Quantum Corporation
500 McCarthy Boulevard
Milpitas, CA 95035 USA

To: T10 Technical committee
From: Russ Brown
Phone: 613-599-2804
Email: russ.brown@quantum.com
Date: 16 January 2001

Subject: Proposal for Ultra320 SCSI timing skew specification for SPI-4

Figure y – Example of transmitter skew

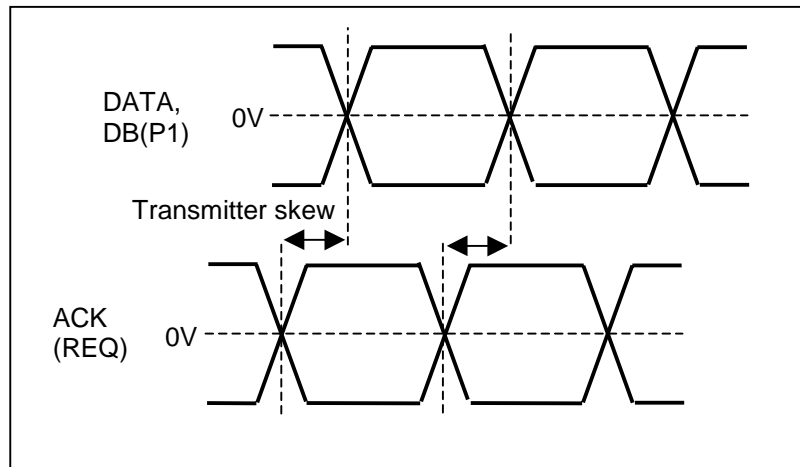
9.2.a Transmitter skew

The maximum difference in time allowed between the rising or falling edge of a “1010...” pattern on the DATA BUS or DB(P1) and its clocking signal on ACK(REQ) as measured at their zero-crossing points. The signals for the output waveforms shall be measured at the connector of the transmitting device and generated under the test conditions as described in A.2.6 (i.e., 500 mV peak amplitude and 1 ns rise and fall time (20% to 80%)).

Figure x – Example of transmitter time asymmetry

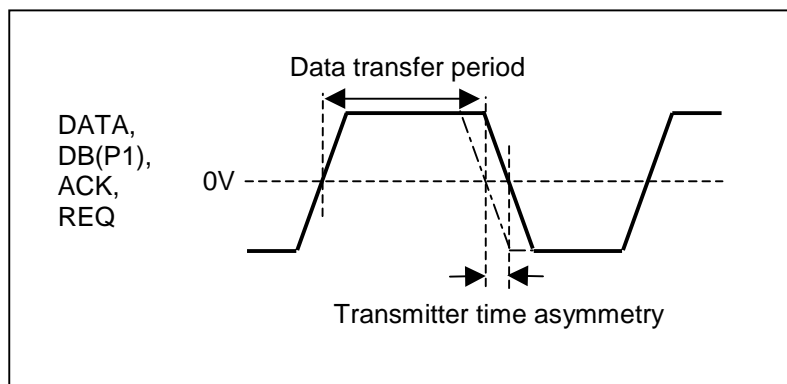
9.2.b Transmitter time asymmetry

The maximum time on DATA BUS, DB(P1), or ACK(REQ) from a rising edge to the subsequent falling edge of a “1010...” pattern as measured at their zero-crossing points minus the data transfer period or a falling edge to the subsequent rising edge of a “1010...” pattern as measured at their zero-crossing points minus the data transfer period. The signals for the output waveforms shall be measured at the connector of the transmitting device and generated under the test conditions as described in A.2.6 (i.e., 500 mV peak amplitude and 1 ns rise and fall time (20% to 80%)).

Figure z – Example of receiver de-skew parameters

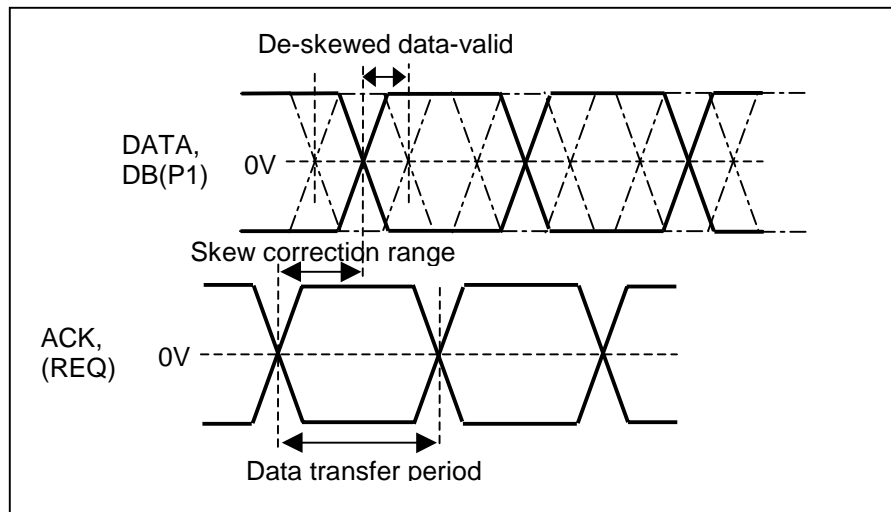
9.2.d De-skewed data-valid window

The minimum difference in time allowed between the rising or falling edge of a "1010..." pattern on the DATA BUS or DB(P1) and its clocking signal on ACK(REQ) as measured at their zero-crossing points after skew compensation is applied by the receiver without allowing any error in the received data. The de-skewed data-valid window shall be equal to $\pm [(\text{data transfer period}) - (\text{residual skew error}) - (\text{strobe offset tolerance}) - (\text{clock jitter}) - (\text{receiver amplitude skew}) - (\text{chip noise}) - (\text{system noise at receiver}) - (\text{receiver asymmetry})] \div 2$. The signals for the output waveforms from the transmitting device shall be generated under the test conditions as described in A.2.6 (i.e., 500 mV peak amplitude and 1 ns rise and fall time (20% to 80%)).
